**Moreland Planning Scheme
Referral 21 Assemble Brunswick**

Priority Projects Standing Advisory Committee Report

Referral 21: Assemble Brunswick

22 November 2021

Figure 7 Proposed extent of demolition (red hatching)

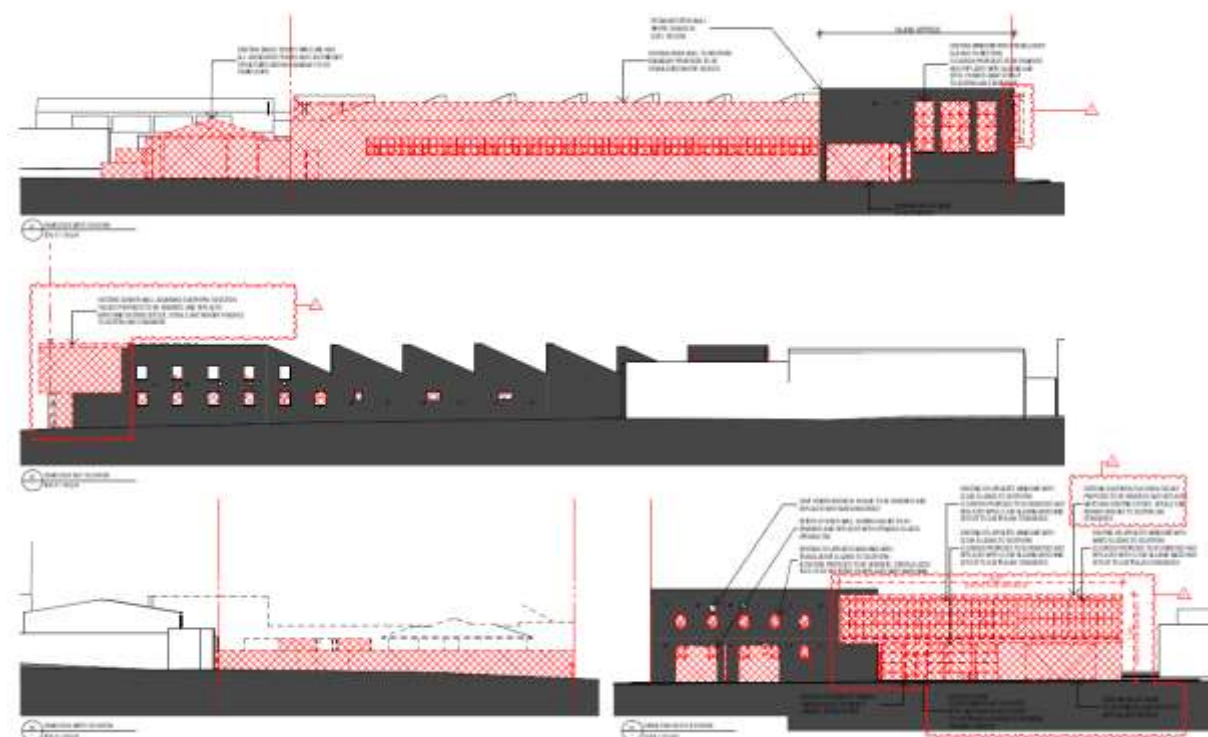
The extent of demolition is shown in the elevations contained in Figure 7 by the red cross hatching.

In response to the extent of demolition, Mr Lewis submitted:

The small setbacks and mass of the new development represents an extreme example of facadism. The scale of the 8 storey building will dominate and overwhelm the former Yakka factory, and the very significant site context.

The proposal completely fails to conform to the heritage provisions of the Moreland Planning Scheme with respect to Clause 15.03-1L Heritage in Moreland, and Clause 43.01 Heritage Overlay.

The Committee agrees with the Applicant that a balance needs to be achieved between the anticipated growth and change in this area of Brunswick and the amount of heritage fabric to be retained. The Committee supports the retention of the built form that is considered most significant (Ballarat Street frontage) and agrees that the Oven Street brick wall (northern section) and the saw-tooth roof can be demolished.

- The demolition of the shroud has not been justified.
- The drafting of Condition 42 (Heritage Works Plan) puts in place a process to overcome the deficiencies of the Facade Observation Report.
- The demolition of the saw-tooth roof and the northern section of the Ovens Street wall is supported.

Figure 9 Figure 2 of DDO18

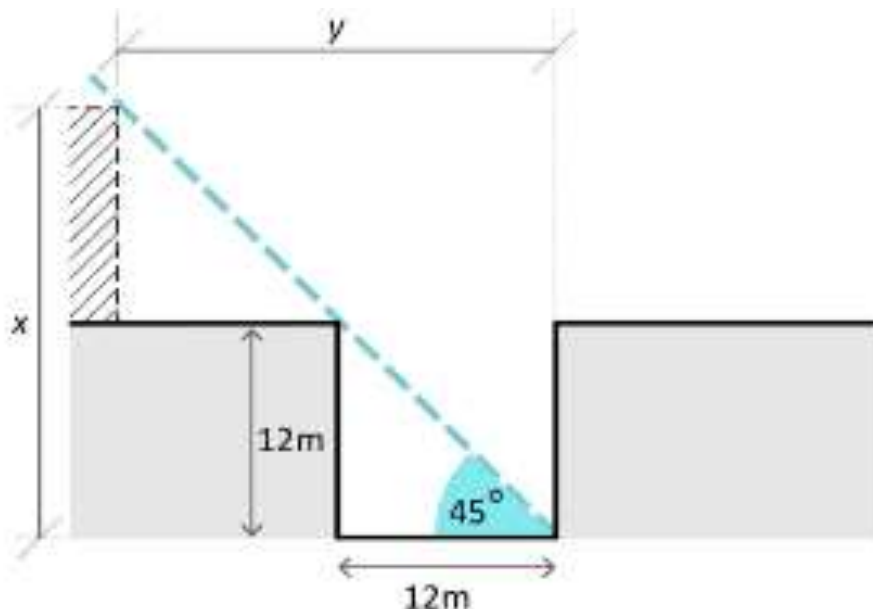
Where a proposal does not comply with the street wall heights it must demonstrate how the design objectives and requirements of the schedule are met.

Figure 12 Comparative analysis of building heights at 8 Ballarat Street (approved, left) and the proposal (right)

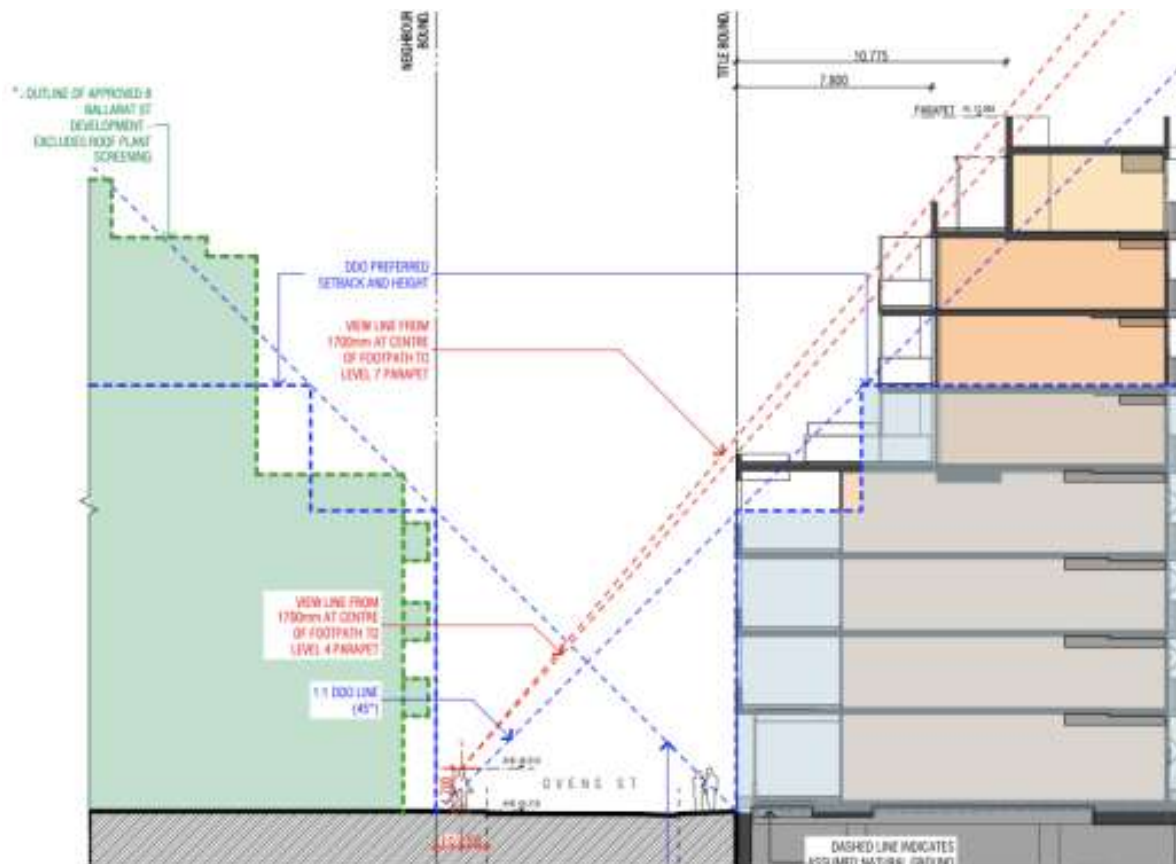
The upper-level setback from Ballarat Street exceeds the 5 metre minimum requirement but on both frontages the height of the building results in an encroachment in the view line from the opposite street boundary at the upper levels. This is shown in Figure 12.

Mr Pryor's opinion was that the upper levels would dominate the view line from Sydney Road and the views from Tripovich Street to the south. He recommended two storeys be removed to address the DDO18 objectives.

The Applicant referred to the approval of an 8 storey development opposite the site at 8 Ballarat Street in support of the proposal. Council in response advised that the 8 Ballarat Street building complied with the preferred street wall height and generally complied with the upper-level setbacks in the DDO18. Council submitted that the site at 8 Ballarat Street had a different context with less heritage implications and that the proposal should be assessed on its merits and not rely on other approvals for development nearby.

The Committee accepts that planning policy for this area of the Brunswick Major Activity Centre will see a significant change to the character of these off-corridor areas. The approved development at 8 Ballarat Street is a good example. A new mid-rise character will eventuate. This is represented by the preferred maximum building heights for the area. The Committee considers there is still some restraint to this new mid-rise character with the use of preferred maximum building heights and the objective to consider the context of heritage buildings.

- The site is encumbered by buildings with heritage significance on and surrounding it and the design must consider this constraint.
- The proposal would result in a mid-rise built form that is expected by policy and DDO18. However, at this height the proposal will unacceptably dominate its heritage context.
- Upper-level setbacks in excess of the DDO18 requirements do not overcome concerns on overall building height.
- A reduced height presents an appropriate balance between the change expected in this area and the need to respect and consider the site's heritage context.
- A reduction in height equivalent to two storeys is appropriate. How this is achieved is for the Applicant to consider.

Figure 18 Equitable Development Plan

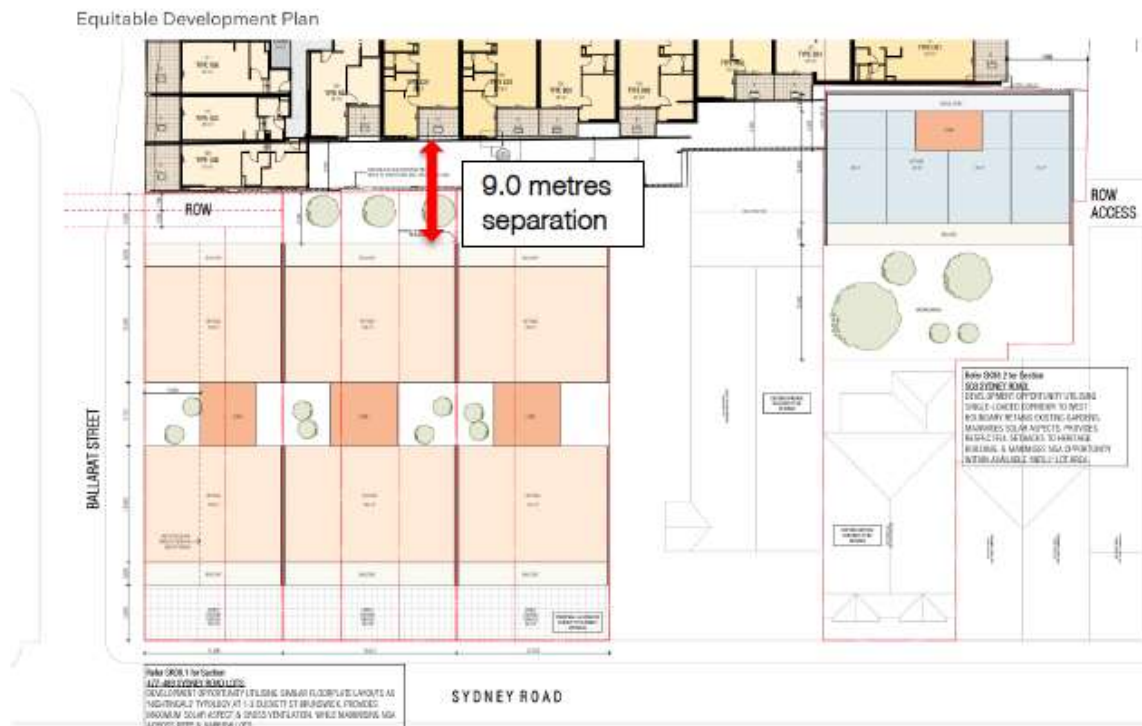
The Applicant relied on the Equitable Development Plan prepared by Fieldwork³ (Figure 18) to show how the setback would interact with adjacent development. The Applicant submitted the 9 metre separation (6 metres at the laneway) was consistent with other inner city municipalities and would provide adequate levels of daylight and outlook.

Ms Roberts also considered the setback of 4.5 metres to be an appropriate response to the interface with the properties at 477-489 Sydney Road.
